Re: Beacon Solar Energy Project, AFC No. 08-AFC-2

**APPLICATION FOR CERTIFICATION FOR  
THE BEACON SOLAR ENERGY PROJECT**

Supplemental Response to CEC Data Request 14 and  
Responses to CEC Data Requests 71 through 127  
Docket No. 08-AFC-2

<b>BEACON SOLAR ENERGY PROJECT (08-AFC-02)</b> <b>CEC STAFF DATA REQUEST NUMBERS 71-78</b>	
<b>Technical Area: Biological Resources</b>	<b>Response Date: October 13, 2008</b>

**Figure 5.17-7**  
**Cone of Depression at the End of**  
**the Well No. 63 Pumping Test**  
**(Revised October 2008)**

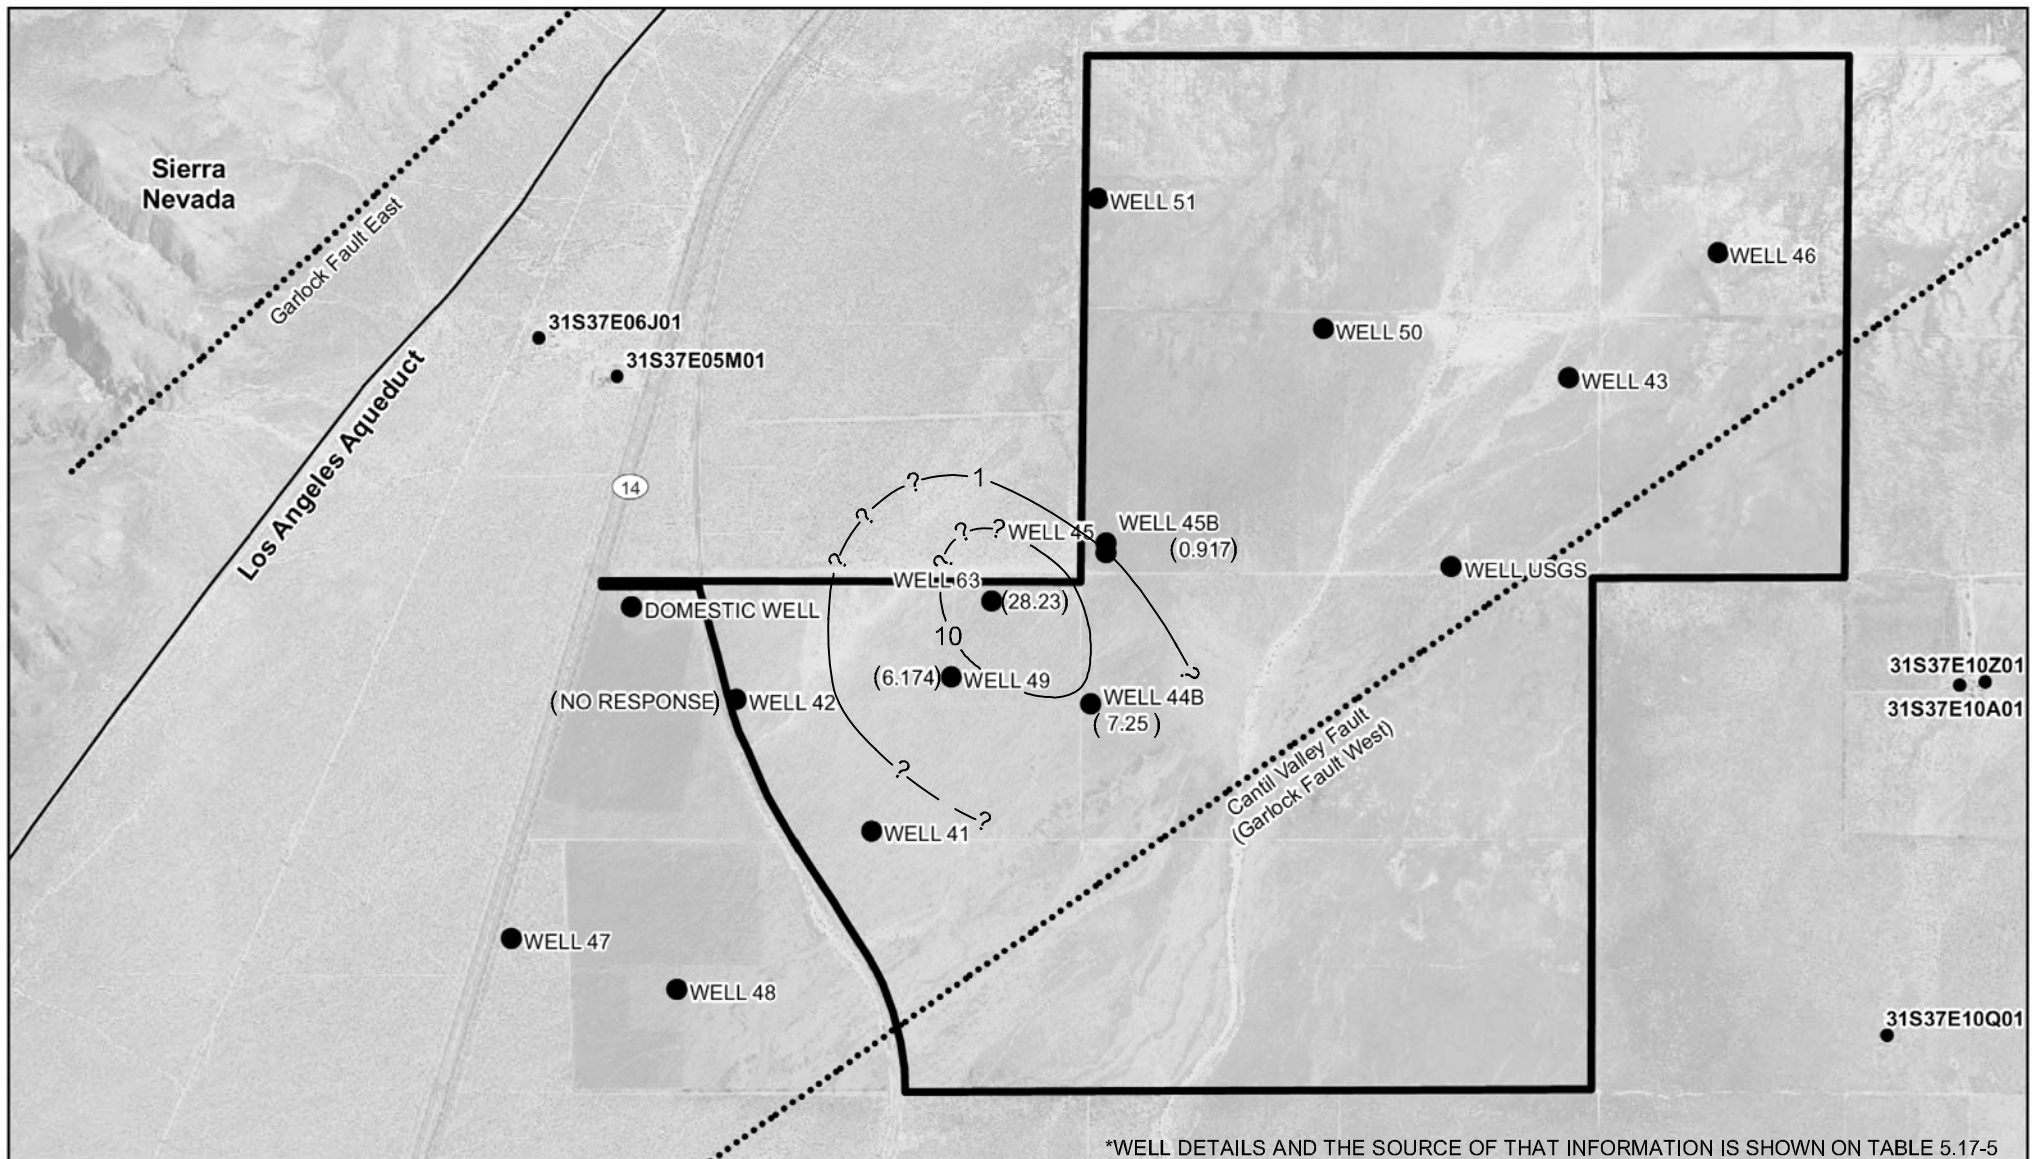
Please revise and provide to staff Figure 5.17-8 to represent actual measured conditions. In areas where there is no data to support the interpretation, please indicate by using appropriate symbols.

All figures associated with the pumping test program (Figures 5-17.7, 5-17.8 and 5-17.9) have been revised as requested to reflect the appropriate uncertainty for the interpretation of drawdown for each pumping test. These figures follow the format of Figure 5-17.10, and have been annotated to show the drawdown for each of the observation and the pumping wells at the end of the test prior to the pump being shut off. Table J.3-5 from Appendix J.3-5 of the AFC contains the data for the water levels used to construct these figures and is provided below.
